Mick Seaman

This note describes modifications to RSTP and MSTP to deal with fragile bridge implementations whose control plane spanning tree protocol operation (including BPDU transmission) can stop while their data planes continue to relay frames. At present such brainless bridges can cause frame forwarding loops, as other bridges naturally transition their own ports to Forwarding.

Figure 1 shows the proposed BDM.

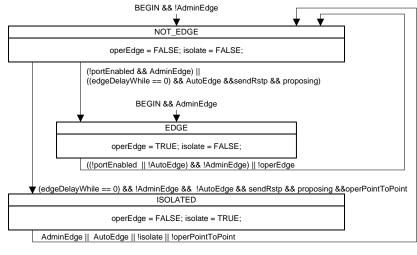
- PRT: In the transition conditions from PRT:DESIGNATED_PORT to DESIGNATED_LEARN and DESIGNATED:FORWARD add "&& !isolate". transition condition In the from PRT:DESIGNATED_PORT to DESIGNATED_DISCARD to add isolate" "|| immediately after "|| disputed". In the PRT:DESIGNATED_PORT actions add "if (cist) {proposing = proposing || (!AdminEdge && !AutoEdge && operPointToPoint);}"
 - PRX: In the PRX:RECEIVE actions clear isolate, and make the initial value of edgeDelayWhile MigrateTime (as before) or IsolateTime (if AdminEdge and AutoEdge both False).
 - BDM: Add another state BDM:ISOLATED. Clear operEdge and set isolate in this state.

In the current states BDM:EDGE and BDM:NOT_EDGE clear isolate.

Add || (!AdminEdge && !AutoEdge) to the transition condition from BDM:EDGE to BDM:NOT_EDGE. This addition allows for a change to these variables while the port is enabled.

Transition from BDM:NOT_EDGE to the new state BDM:ISOLATED on the condition "(edgeDelayWhile == 0) && (!AdminEdge && !AutoEdge) && sendRstp && proposing && operPointToPoint"

TransitionfromBDM:ISOLATEDtoBDM:NOT_EDGEontheconditionAdminEdge||AutoEdge || !isolate || !operPointToPoint.

Change the transition conditions from BDM:NOT_EDGE to BDM:NOT_EDGE by replacing "!portEnabled" with "(IportEnabled || !AutoEdge)".

Figure 2—Changed Port Receive state machine based on correction to 802.1ah

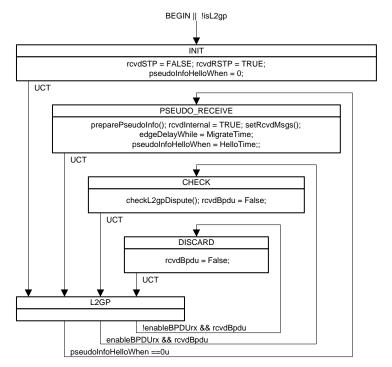
Figure 2 and Figure 3 contain a corrected Port Receive (PRX) machine and a suggested L2 Gateway Port Receive (L2GPRX) machine as a replacement for the

existing Port Receive Pseudo Information state machine. The latter does not change the main

functionality of the machine, but clears up some minor $issues^1$.

Figure 5—Changed Port Role Transitions state machine (change from 802.1Q-2006/2008)

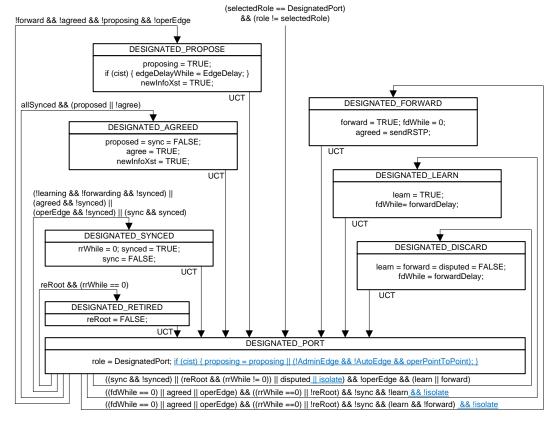
Figure 5 is an updated PRT (Designated Port states only), based on the 802.1Q-2008 Edition in preparation state machine, which I don't believe has changed from the 802.1Q-2006 edition.

Figure 4—Changed Port Information state machine (change from 802.1Q-2006)

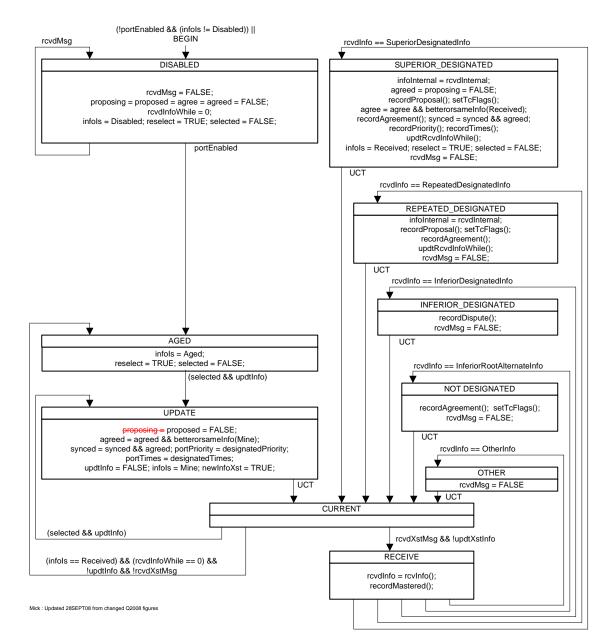
— PIM: In PIM:UPDATE remove proposing from proposing = proposed = FALSE. Note that this change should be entirely harmless so far as other RSTP/MSTP functionality is concerned, clearing proposing here appears to have been quite unnecessary in the first place.

Figure 4 is an updated PIM, based on the 802.1Q-2006 state machine (i.e. without the incorrect 802.1ah change).
